DEVELOPMENT APPLICATION

PROPOSED MIXED USED DEVELOPMENT:
BASEMENT CARPARK / RETAIL PRECINCT & APARTMENTS (CLASS 7A, 6, 2)

Project
9 MARVELL ST
Client
COBILD

Drawing Name
COVER - CHANGES DRA 01 & 02
Location
9 MARVELL ST BYRON BAY
NSW 2481

Drawing Name
BASEMENT - CHANGES
Location
9 MARVELL ST BYRON BAY
NSW 2481

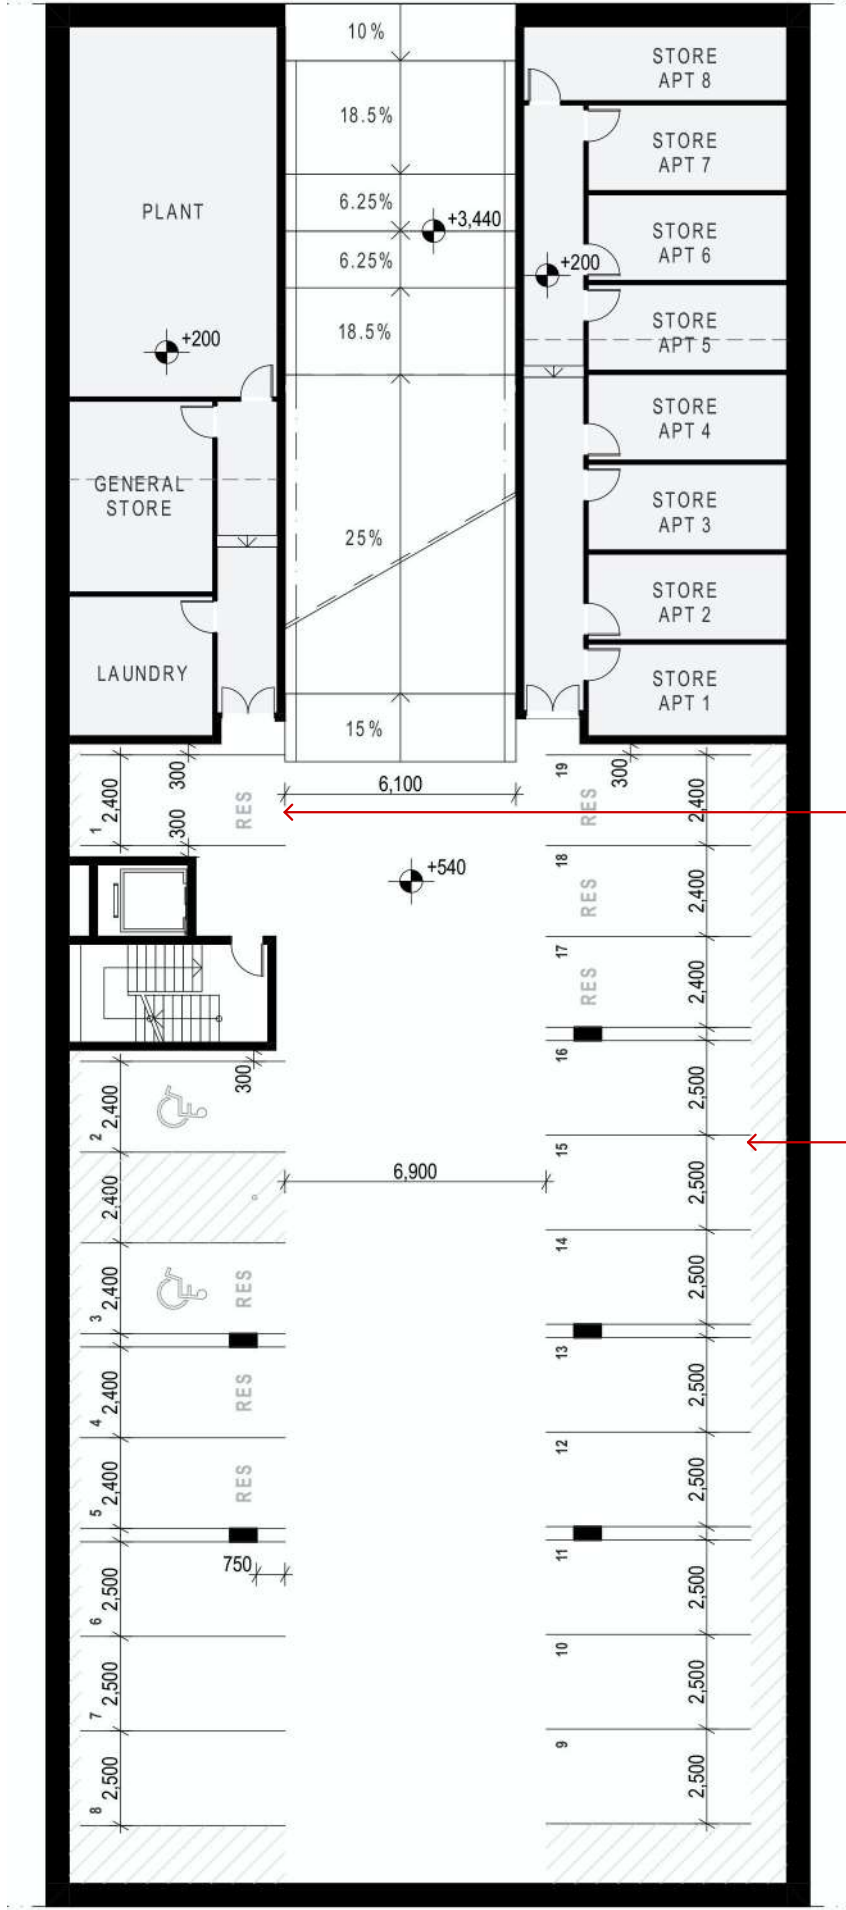
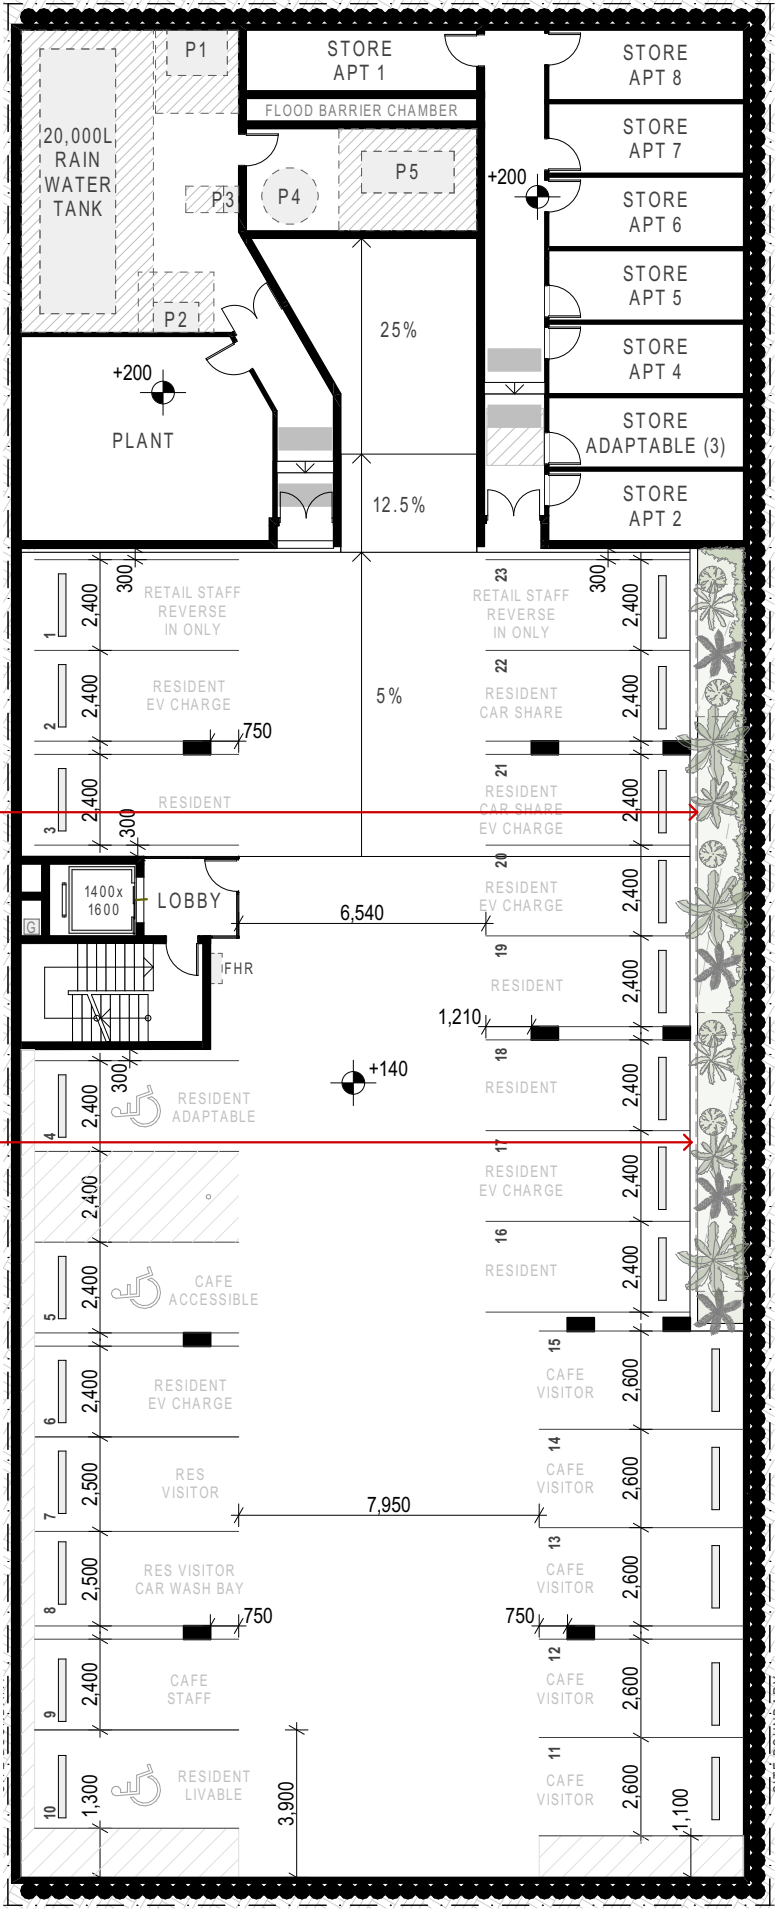
1.04	Increase the area of the courtyard by relocating GFA as previously noted.	Addressed in current design
1.05	Investigate the possibility of opening the car park to the sky along the eastern boundary and relocating planting to the car park level. It is understood that ground water conditions may not allow this.	Addressed in current design

1.08
Current parking layout meets minimum parking requirements for program, generous void to ground floor provided to eastern boundary

1.05 / 2.02
Introduce 1250mm deep void to GF slab (18.7m long) providing dramatic natural light amenity to car park and forming continuity in greenscape between ground plane and subterranean car park.

Drawing Name
GROUND FLOOR - CHANGES
Location
9 MARVELL ST BYRON BAY
NSW 2481

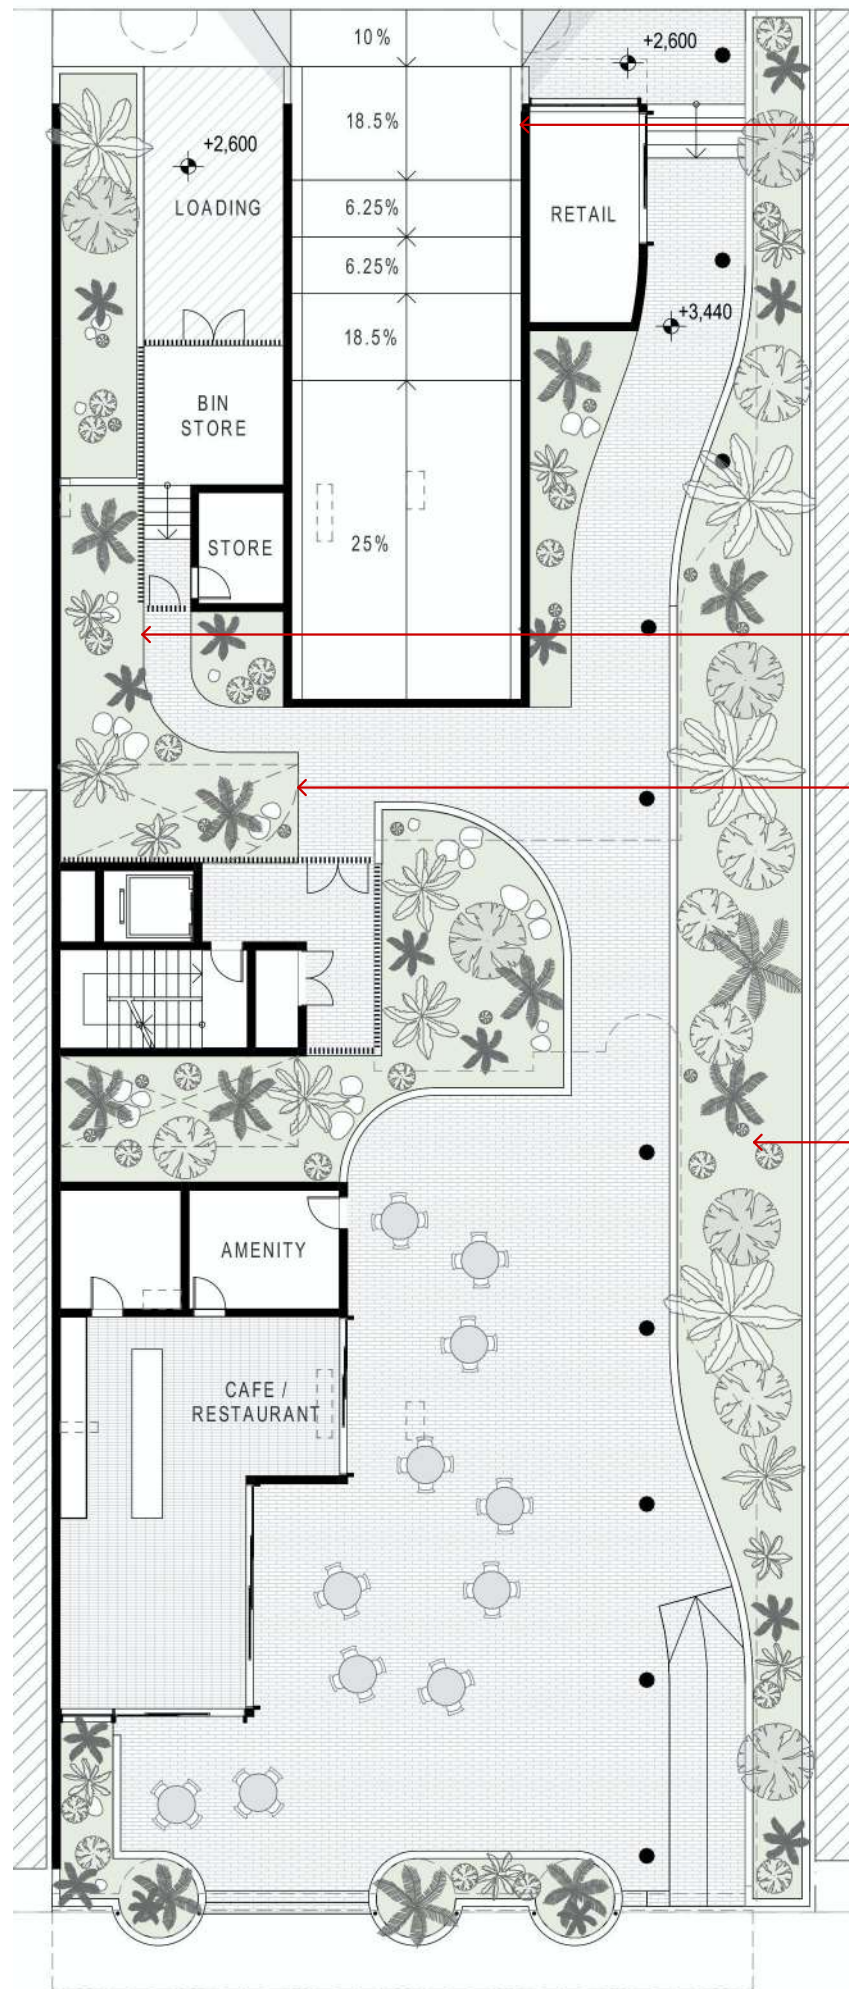
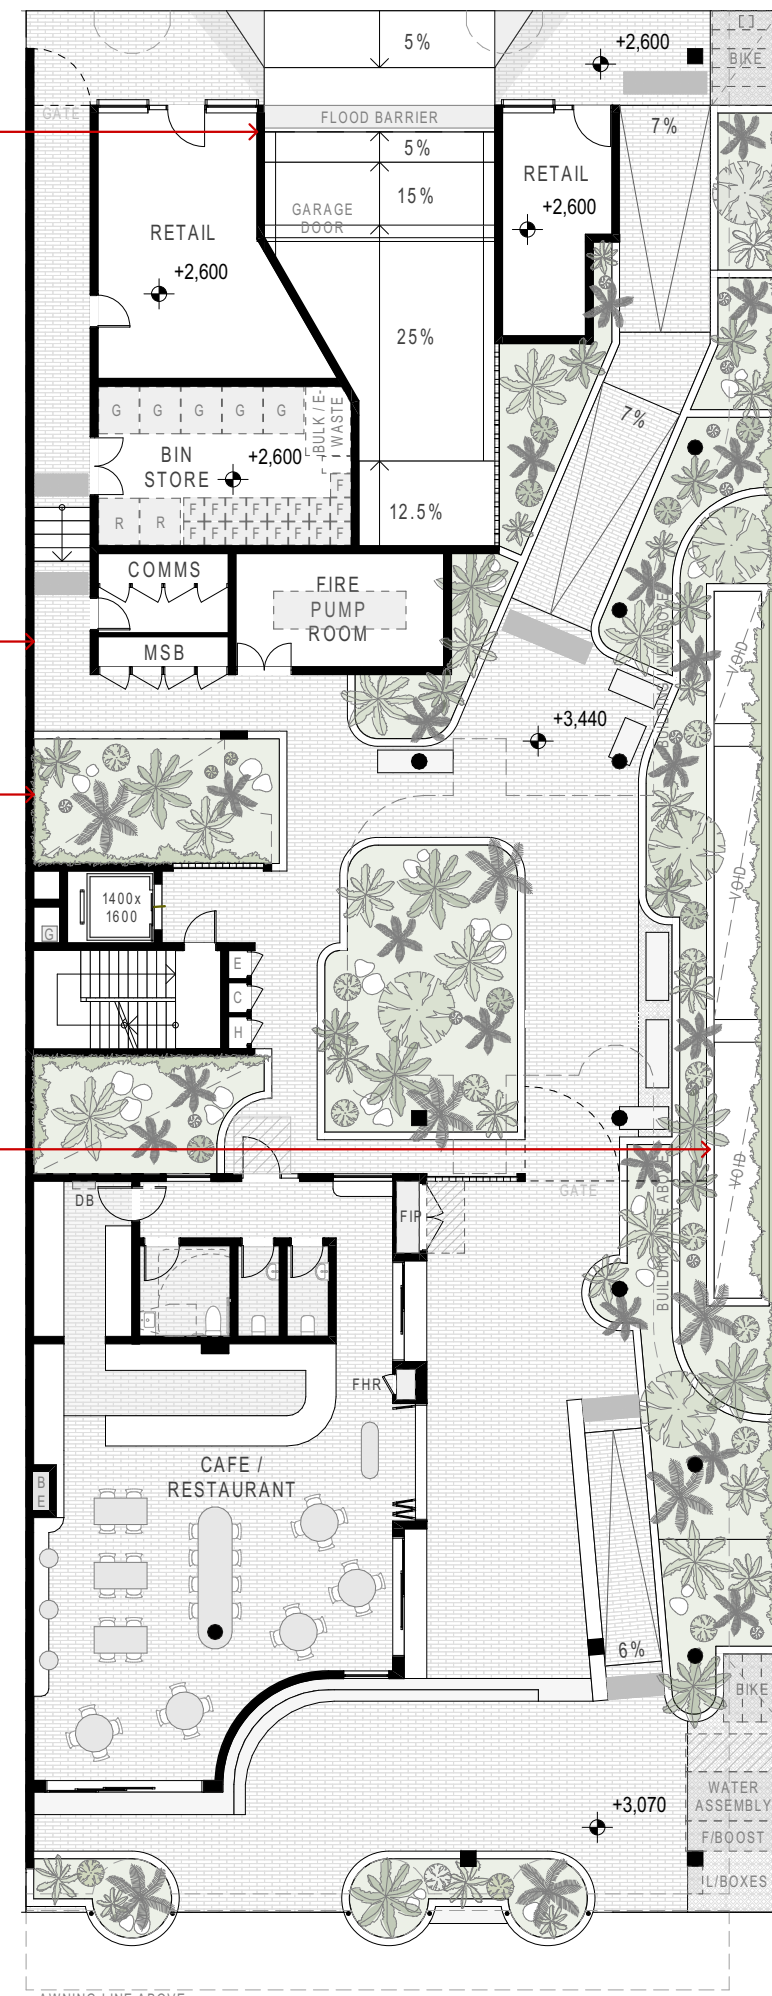
1.06	Plants in the under cover area along the western boundary are unlikely to survive. This area may be needed for egress in any case; deleted and resolve.	Addressed in current design

2.01	Address street presence and human scale of ground plane to Fletcher Lane, current design presents some lofty and cavernous spaces (vehicular basement ramp, loading bay).	Addressed in current design
2.02	Consider enlarging void to basement to increased light access and continuity of vegetation between basement a ground level - possibility of palms panted to basement, with green bulk growing at or past ground level.	Addressed in current design
2.03	Consider a discrete location on Marvel St for development signage.	Addressed in current design

2.01
Tilt garage door introduced to Fletcher Lane
reducing open void space, top datum aligned
to windows improving human scale to ground
plane

1.06
Planting locations with no/low solar access
removed

1.03
Engaged landscape architect (Florian Wild)
for expertise in selection of species for
purposes of resilience in low light areas

1.05 / 2.02
Introduce 1250mm deep void to GF slab
(18.7m long) providing dramatic natural light
amenity to car park and forming continuity in
greenscape between ground plane and
subterranean car park.

Drawing Name
TYPICAL FLOORS - CHANGES
Location
9 MARVELL ST BYRON BAY
NSW 2481

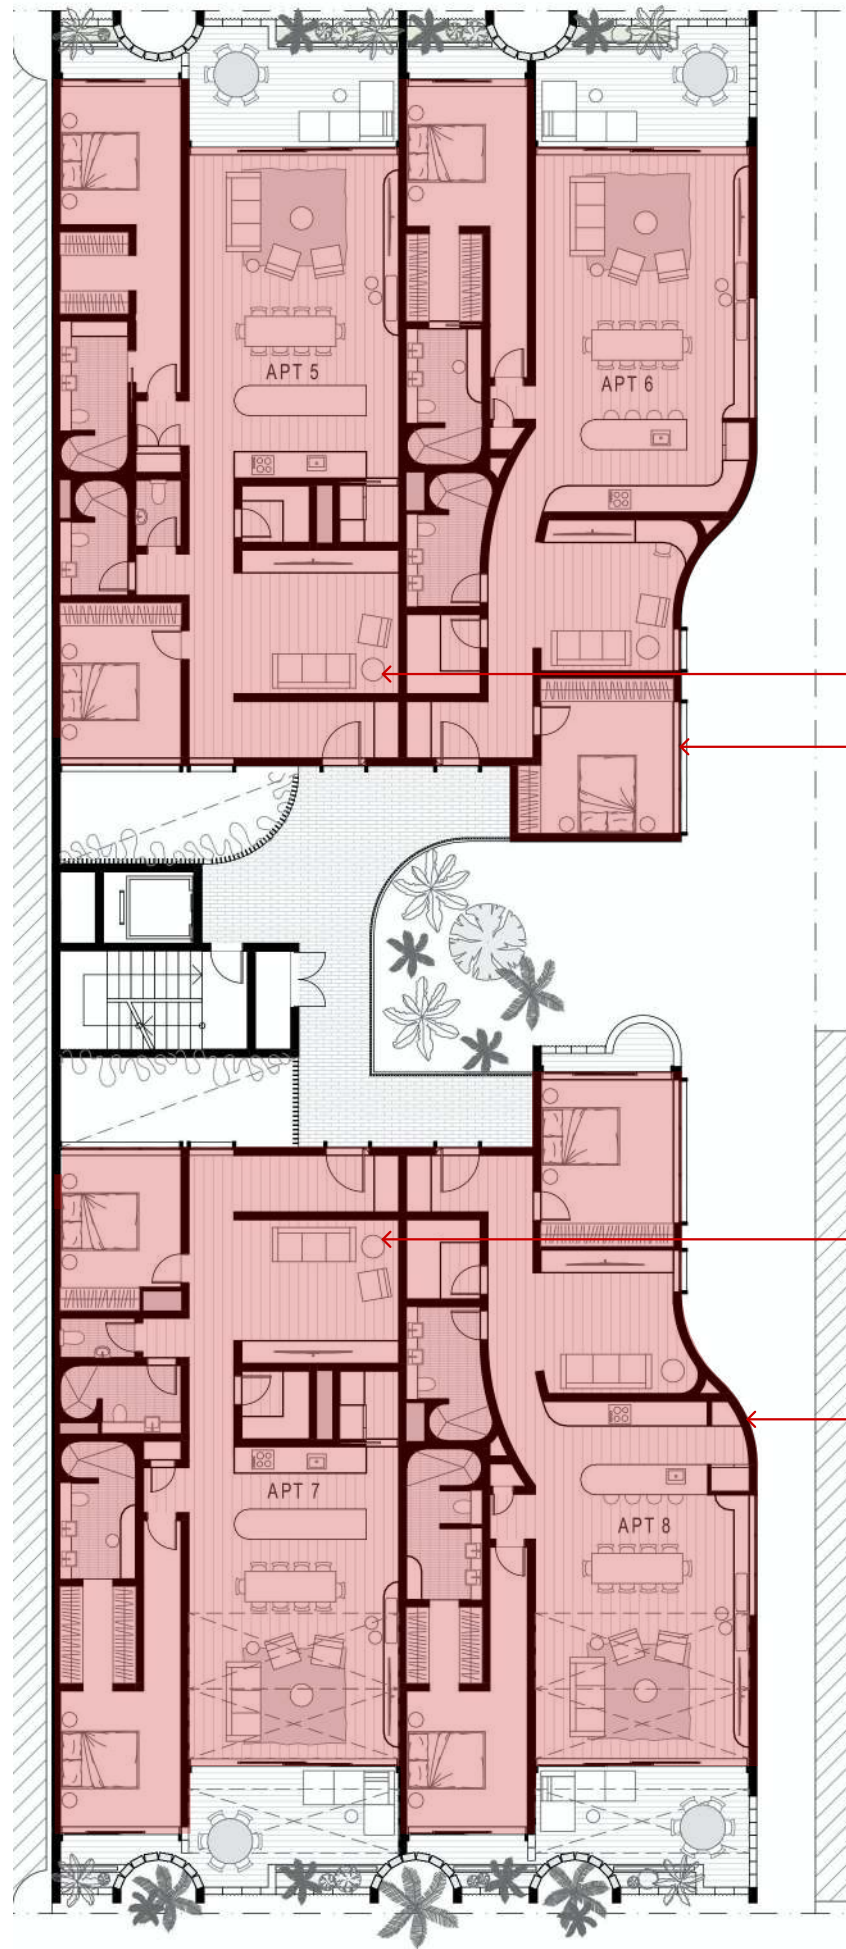
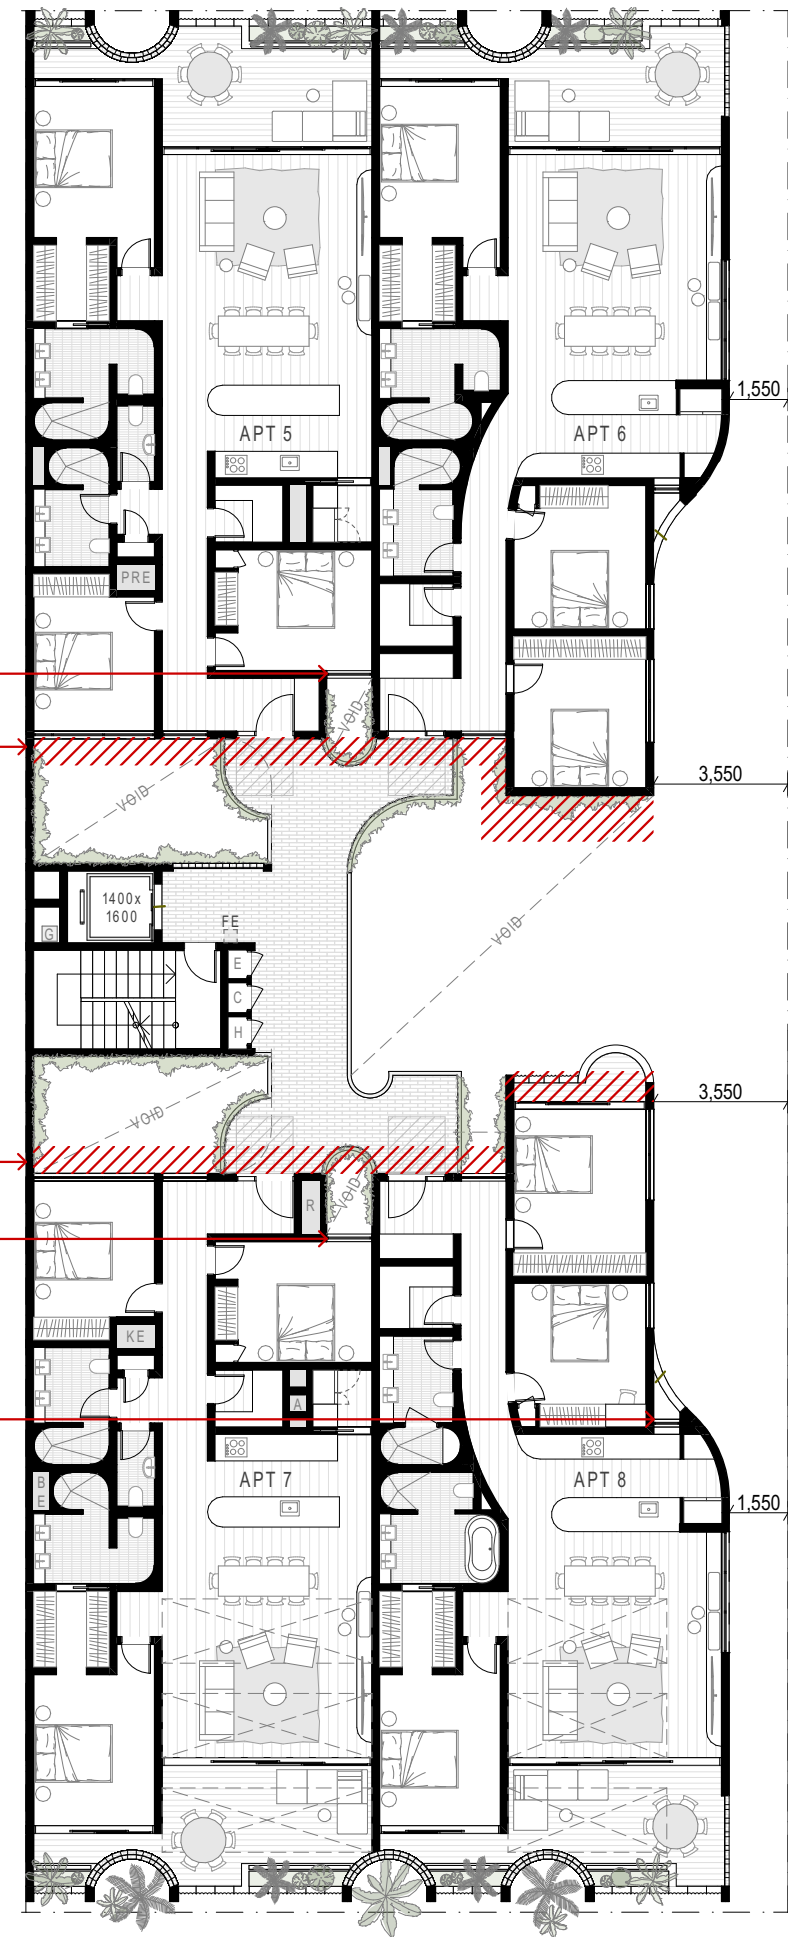
1.01	Investigate redistribution of some of the GFA from the upper levels to the ground level. Removal of the second living areas and some of circuitous circulation (about 95sqm per level) and relocation of 190sqm of GFA to ground level would open the courtyard and significantly improve its amenity.	Addressed in current design

1.02	Solar access to the living area of Apts 4 and 8 could be provided by re-arranging the pantry	Addressed in current design
1.03	Engage a landscape architect with particular expertise in species selection to ensure the proposed plants will survive and thrive in the overshadowed spaces. In some areas the plants will not receive direct sunshine for much of the year and in some places none of the year.	Addressed in landscape architect report

1.07	Consider reducing the area and inclusions in some of the apartments (2 bedrooms with 2 bathrooms, 3 WC and 'media' rooms work against affordability)	Addressed in current design

Provide natural light amenity to third bedroom

1.01 / 1.04 / 1.07
Reduce GFA to apartments, increase courtyard size, improve daylight amenity to apartments and to ground plane

Courtyard total width increased by 1.5m (from 10m to 11.5m). Total apartment GFA decreased from 1190m² to 1120m²

Provide natural light amenity to third bedroom

1.02
Introduction of north-facing glazing for solar access to living spaces (apt 4 & 8)
